DESIGN JOURNAL 2023/24 SEMESTER A

Emma Senesael
Architecture

Architectural Design Studio 2
5CTA1141-0906-2023

Community Arts Centre

Floorplan Output AutoCAD

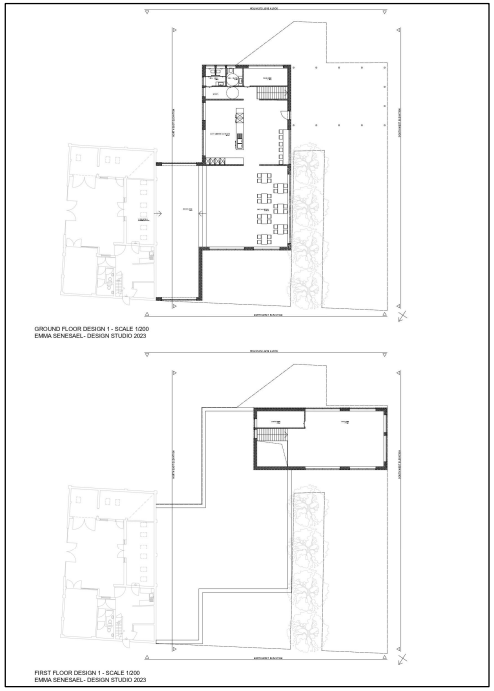
TEACHER NOTES DURING DISCUSSION

- IMPACT OF SUNLIGT

- DESIGN A GARDEN

- ADJUST SEATING SO THERE IS SUNLIGT DURING THE WHOLE DAY

- WALL STRUCTURE DOES NOT NEED TO BE SPLITED UP

- RETHINK WINDOW DESIGN THINKING ABOUT WHICH MATERIAL YOU'RE GOING TO USE

32 / 3TH CRIT PRESENTATION

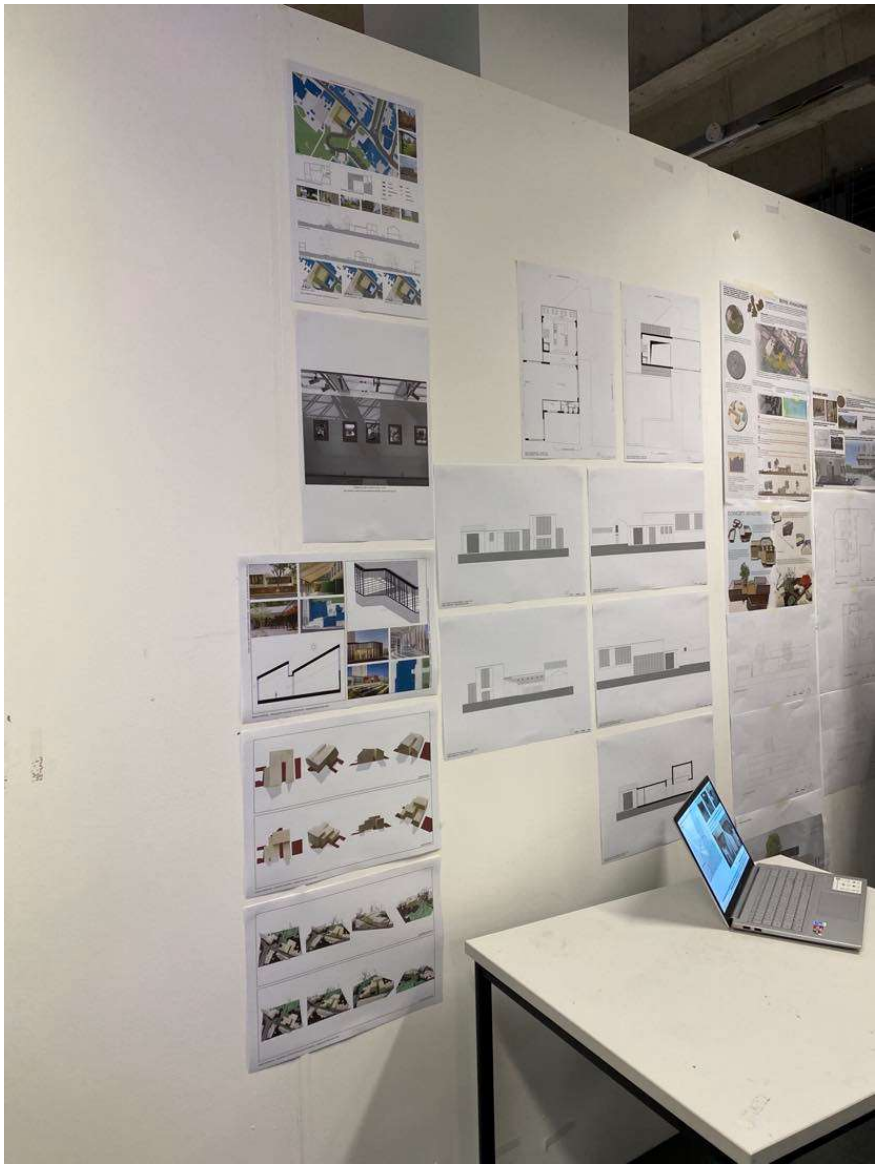
[GOOD]
- Proposal is clear
- Clear diagrams in your site analysis
- Interesting massing models.
- Good precedent study.

Use the different roof height from your precedent in your design proposal.

[NEED IMPROVEMENT]
- Put design in context with site.
- Make your orientation consistent
- Add existing building to your floor plans.

- Add context in your elevations and sections.
- Add a site plan 1:200.

- Café seating area is a bit restricted, Especially in the kitchen area
- Add furniture in your design
- Think about how noise will be controlled from the kitchen and café to the events room.
- Think about the height of the cantilever building, … (Add Pillars – Comfort walking under)
